M-1977-410 AM2 Adequacy Review Response #3

RE: Cross Gold Mine, Permit No. M-1977-410, 110(2) Hard Rock Permit Amendment Application (AM-02), Adequacy Review No. 3

Grand Island Resources Cross Mine (M1977-410) Amendment #2 Response to DRMS Comments Dated December 29, 2021

EXHIBIT E - CROSS AND CARIBOU MINES MINING PLAN MAP: CROSS MINE AND CARIBOU MINE	
Project: CROSS AND CARIBOU MINE - AM 2 APPLICATION	Project No.: 21-1306
Location: NEDERLAND, COLORADO, USA	Date: JAN. 2022

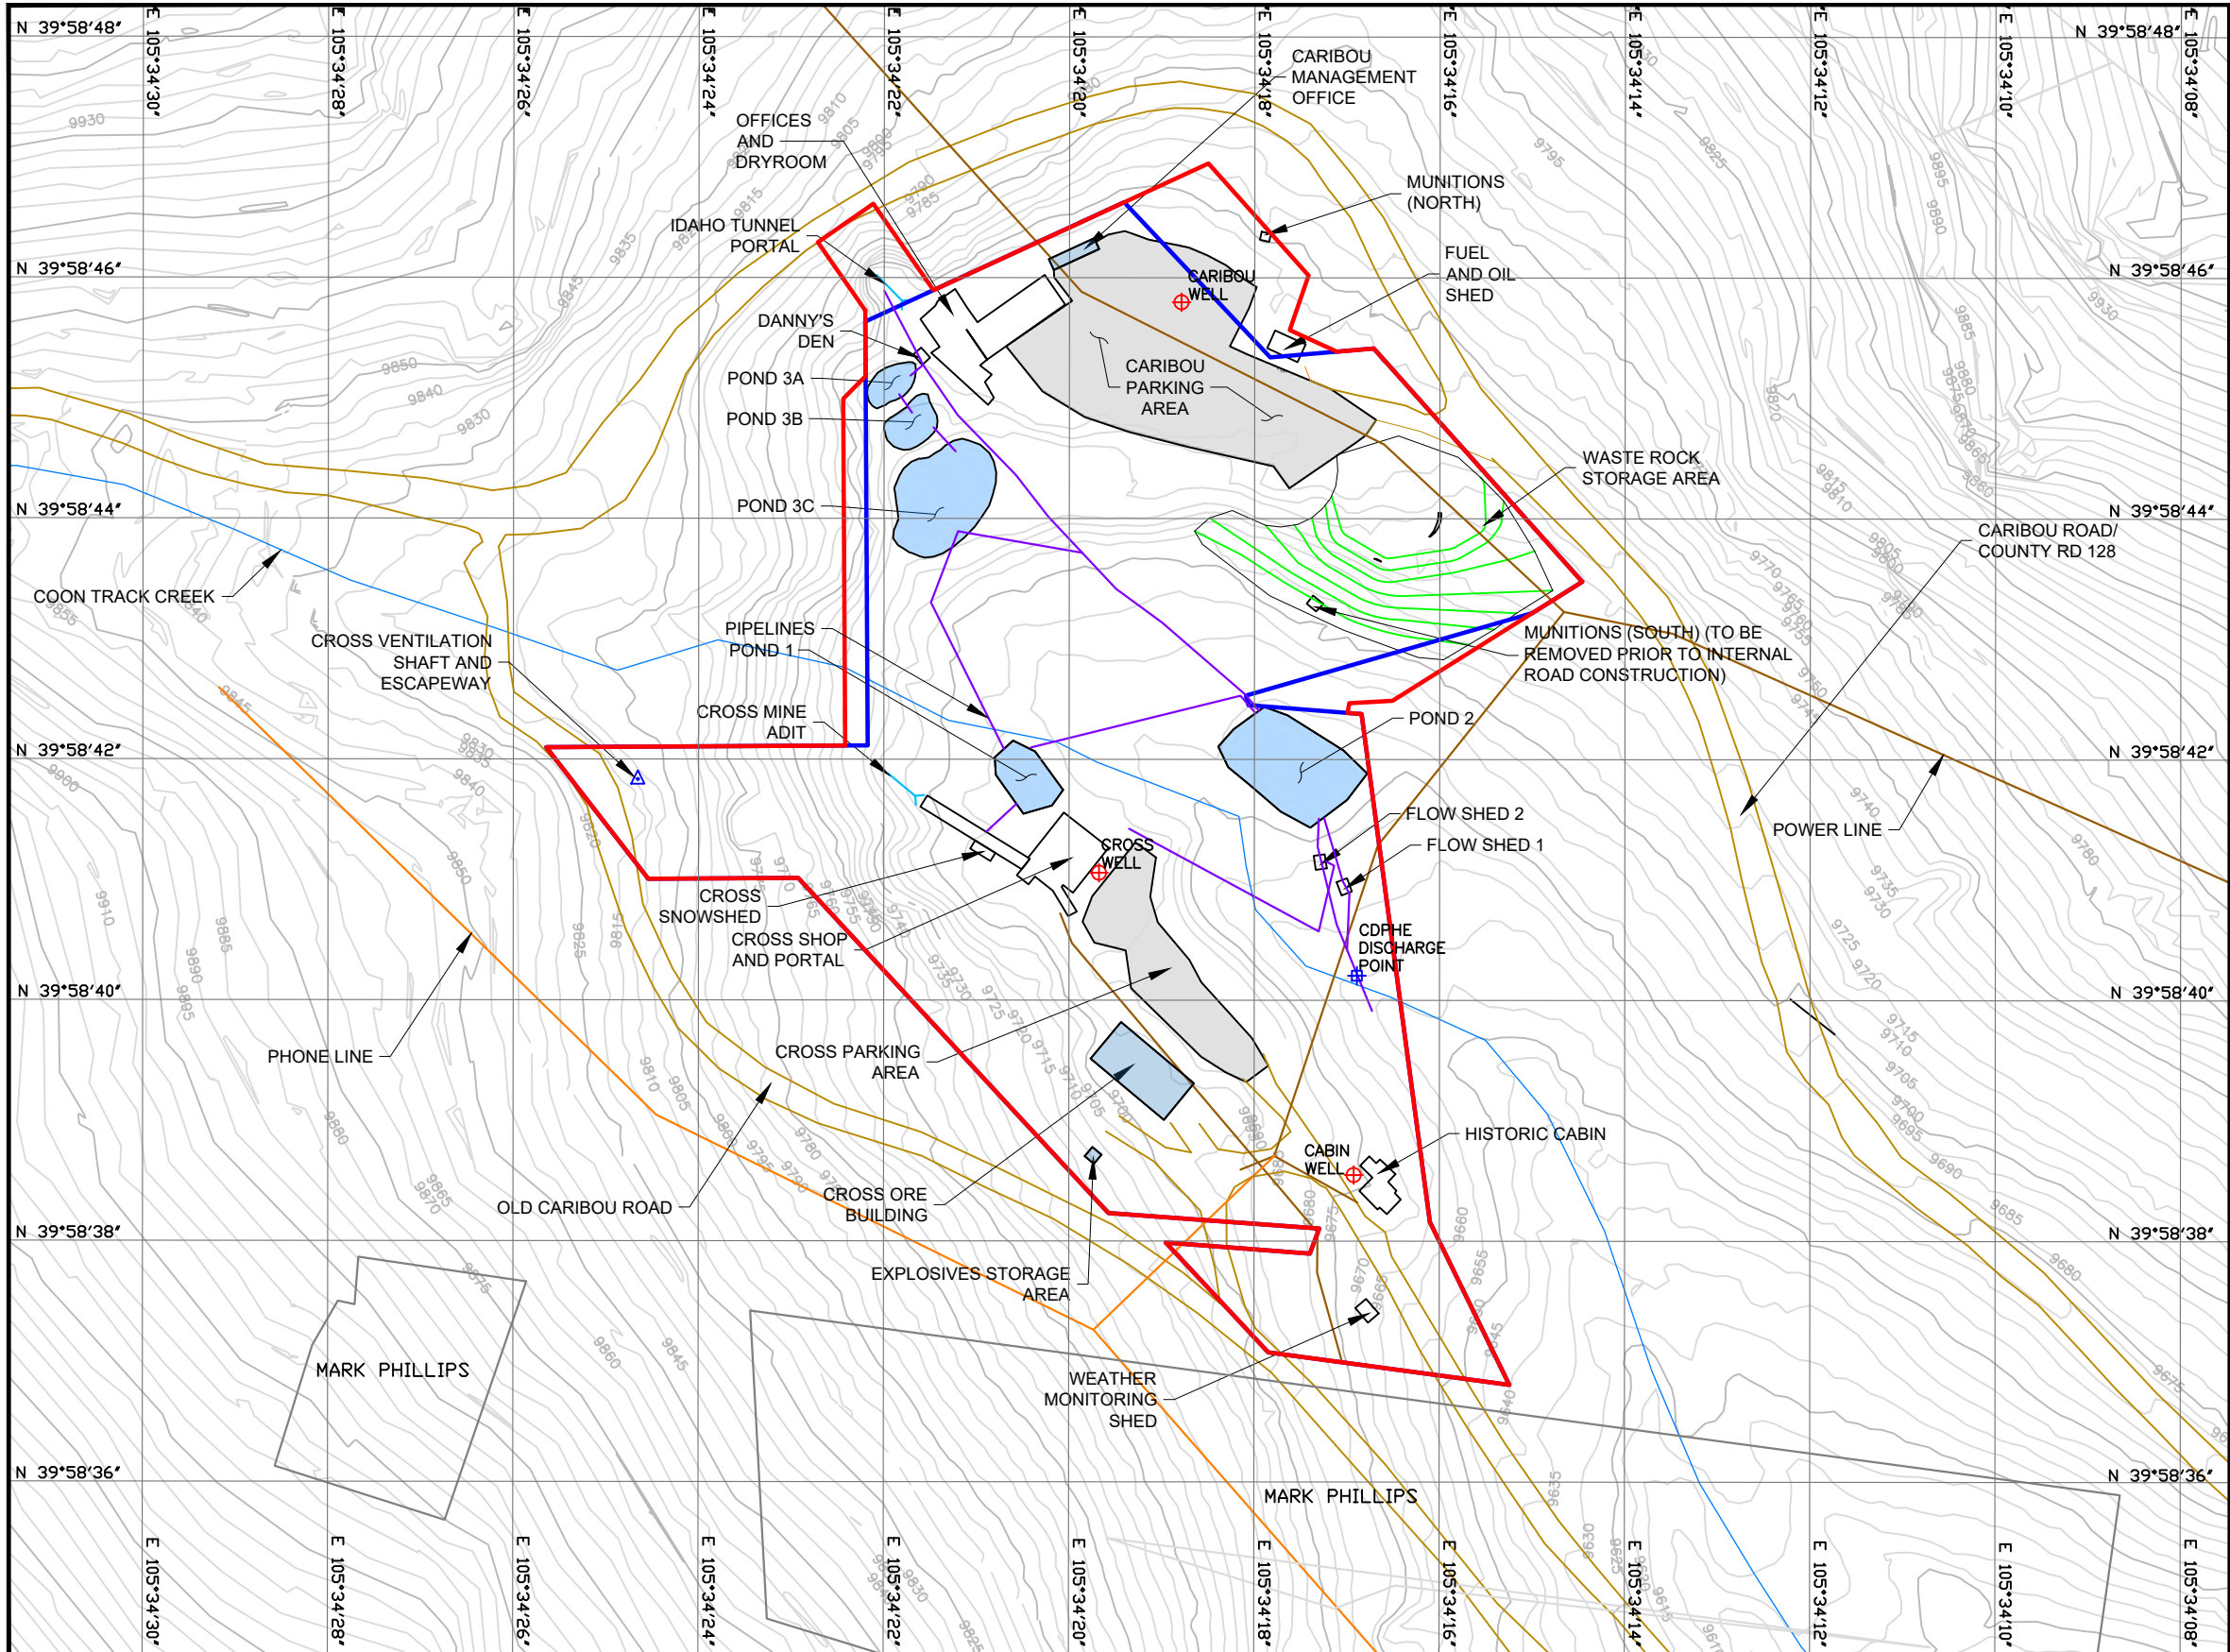
- a. Please add “Exhibit E” and “Mining Plan Map” to the map title.
- b. The “Current Permit Boundary” indicated on the map (with a blue line) and stated in the legend to be 9.36 acres, is not accurate. The current permit area is 8.95 acres, as of the Division’s approval of Acreage Reduction No. 1 on November 12, 2020. Please correct this boundary on the map and correct the acreage in the legend.

- c. Please add the proposed permit acreage (9.6 acres) for the Cross and Caribou mine area.
- d. Please include the names of all landowners within 200 feet of the proposed permit boundary.

- e. Please include the owners of record of all permanent or man-made structures located within 200 feet of the proposed permit boundary. Given the number of structures owned by GIR, the operator may choose to label only the non-GIR-owned structures, and add a feature to the legend explaining that all structures not labeled are owned by GIR. It is the Division’s understanding that Caribou Road, the power line, and the phone line shown on this map, are not owned by GIR.

- f. Please remove the “Ore Storage Area” shown in the Cross Mine area, as the Division does not authorize the operation to continue storing ore at this location (as described above).

i. Please show all water infrastructure, including pipelines (infrastructure specifically related to the new water treatment system should be submitted in the Board-Ordered Technical Revision and not in this application).

Please see revised Map 2 in Exhibit E.

EXHIBIT E - CROSS AND CARIBOU MINES MINING PLAN MAP: CARIBOU 300 AND POTOSI

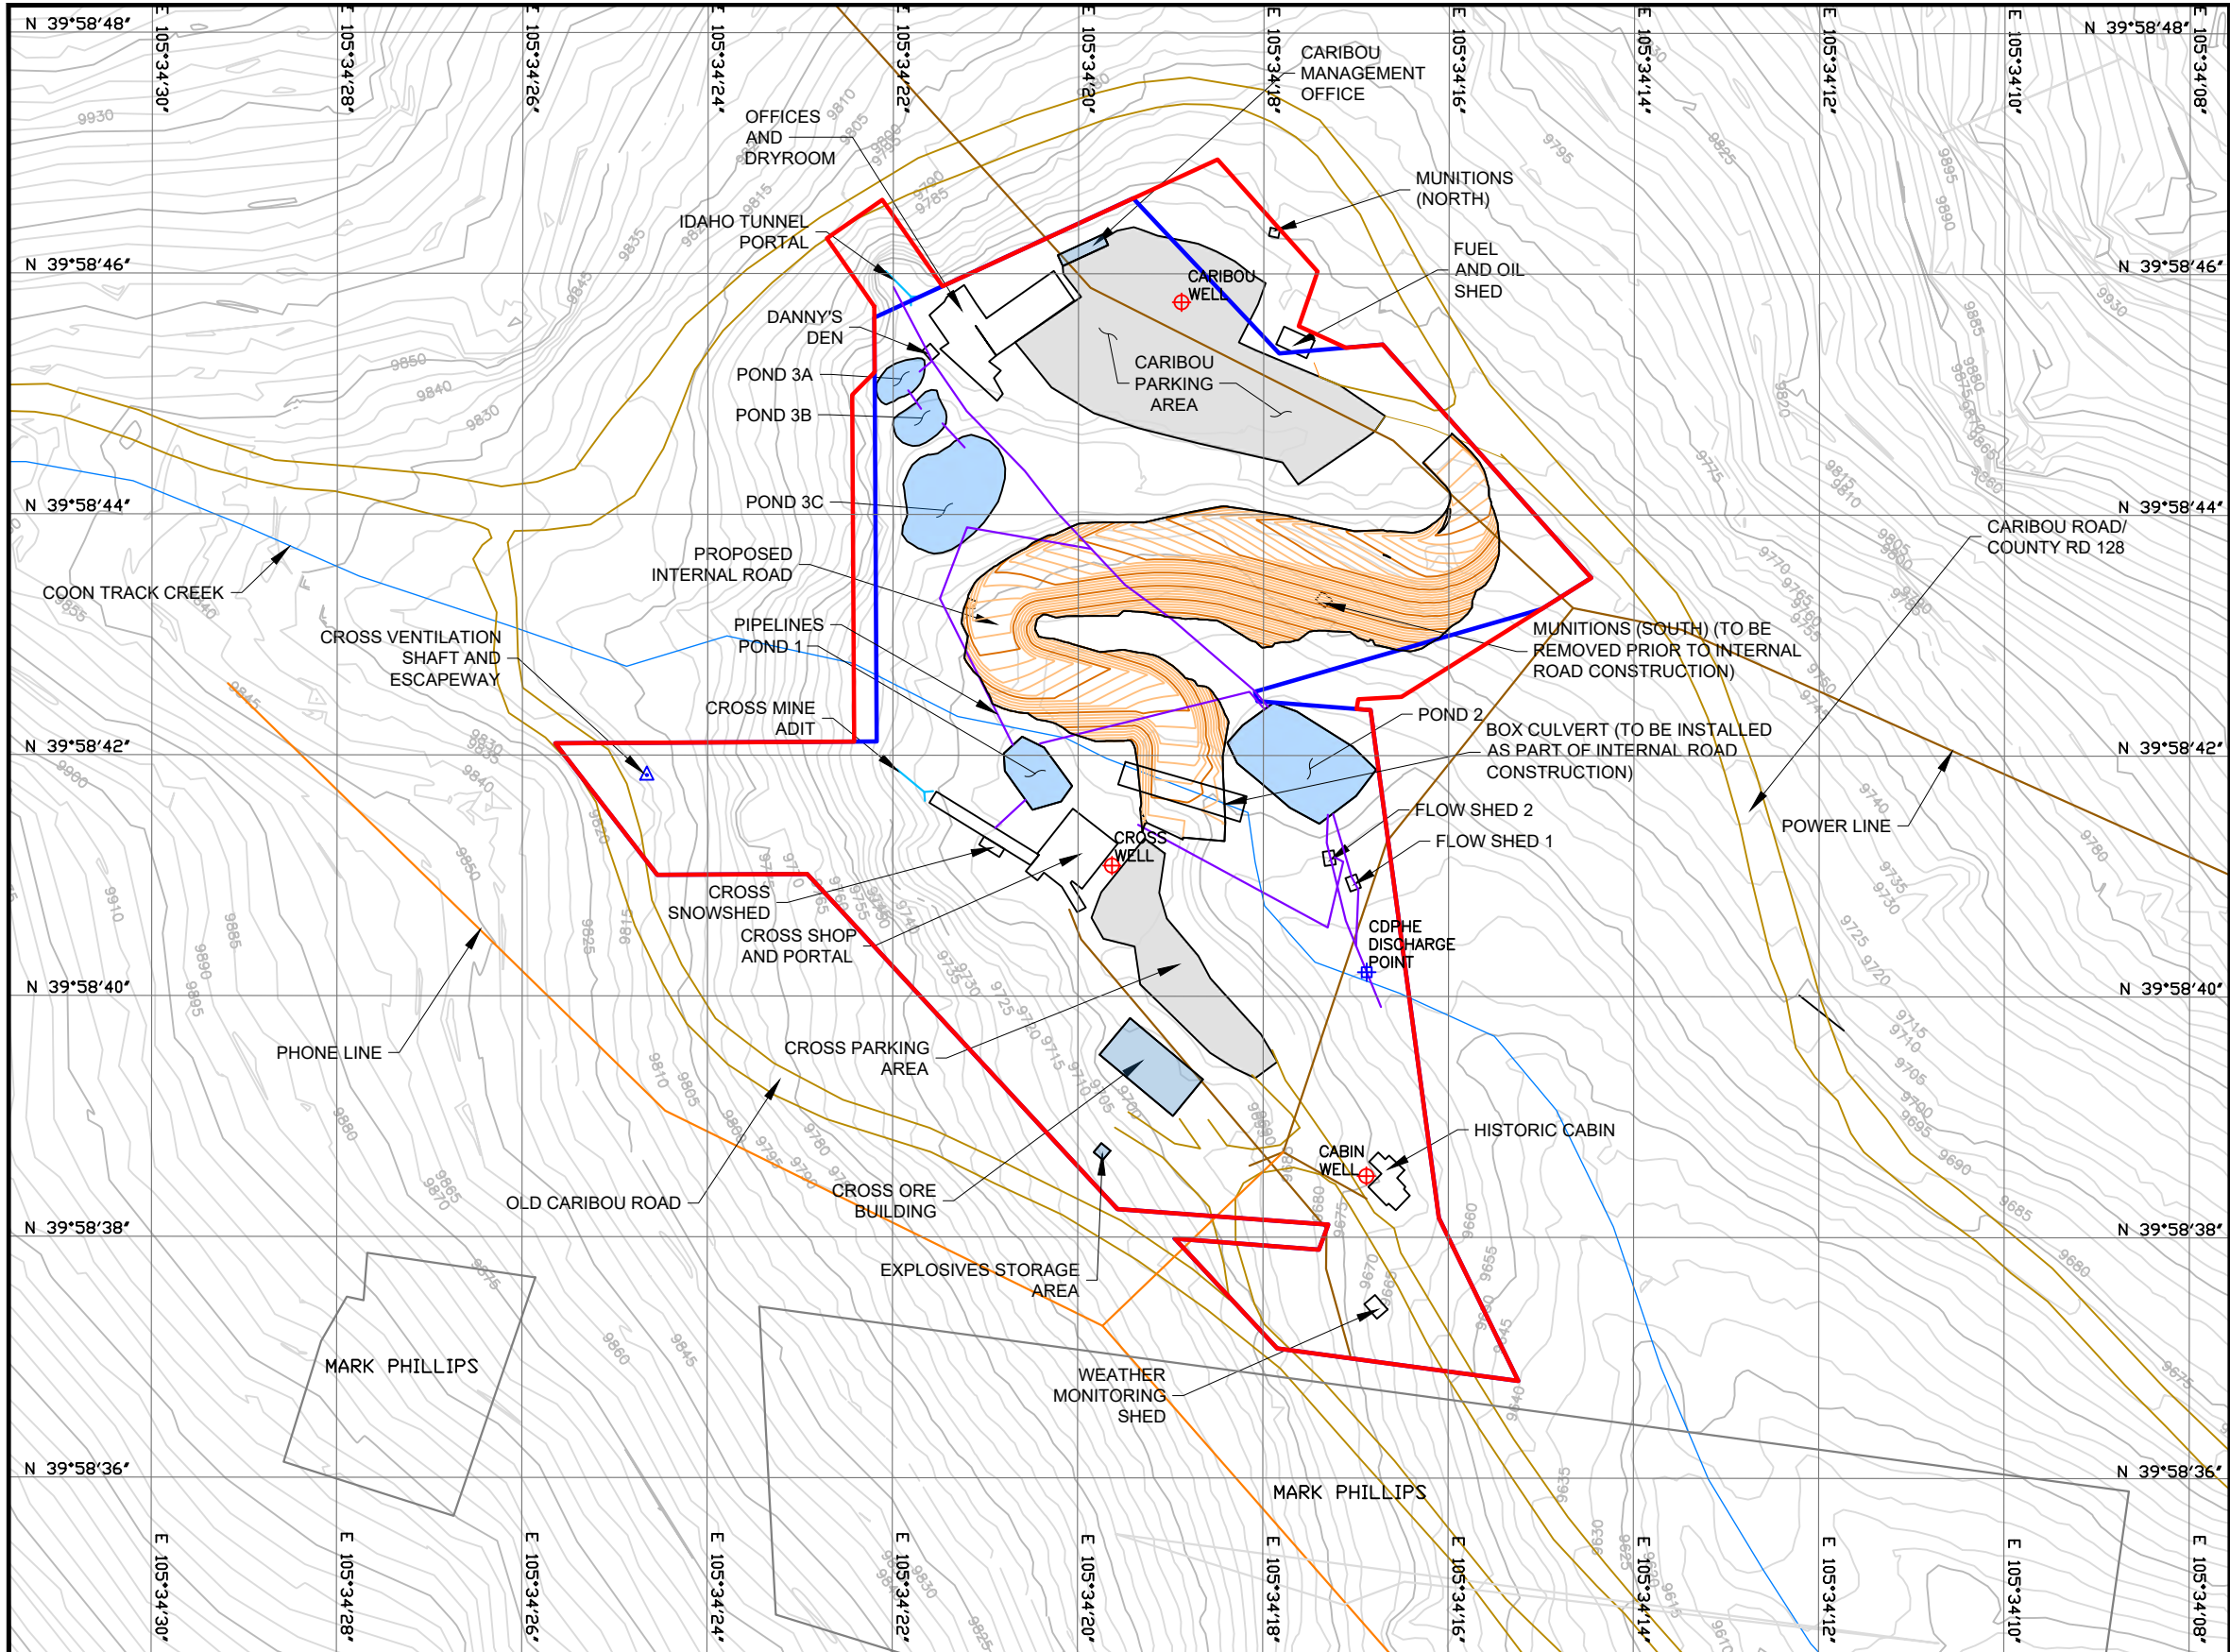
- a. Please add “Exhibit E” and “Mining Plan Map” to the map title.
- b. Please add the proposed permit acreage for the Potosi Shaft (0.06 acre) and Caribou 300 Level Portal (0.33 acre) areas.

- c. Please include the names of all landowners within 200 feet of the proposed permit boundaries.
- d. Please show all permanent or man-made structures located on and within 200 feet of the proposed permit area. For example, the Division is aware of some historic structures located within 200 feet of the proposed Potosi Shaft area, which are not shown on this map.

- e. Please include the owners of record of all permanent or man-made structures located within 200 feet of the proposed permit boundary. The operator may choose to label only the non-GIR-owned structures, and add a feature to the legend explaining that all structures not labeled are owned by GIR. It is the Division’s understanding that Caribou Road and Forest Service Road 505 shown on this map, are not owned by GIR.

- f. The Caribou 300 Level Portal map includes a short access road off of Forest Service Road 505 (not included in the proposed permit area) which, according to Map 7 (and the proposed reclamation plan), will be reclaimed when mining concludes. As stated above, all proposed affected lands must be included within the proposed permit area, including any existing roads which will be substantially upgraded to support the mining operation, or new roads. Therefore, please remove this new road from consideration under AM-02 and modify this map accordingly. The road may be added into the permit area under a subsequent Amendment application.

- a. Changes made as requested*
- b. Changes made as requested*
- c. Changes made as requested*
- d. The abandoned building ruins, shown on Map 3, are owned by GIR*
- e. Changes made as requested. The Caribou Road is owned by Boulder County and The Forest Service Road is owned by the U.S. Forest Service. There are no utilities installed in the Caribou Level Portal or Potosi Shaft areas*
- f. This road was removed from the map, tables, and text.
Please see revised Map 3 in Exhibit E.*
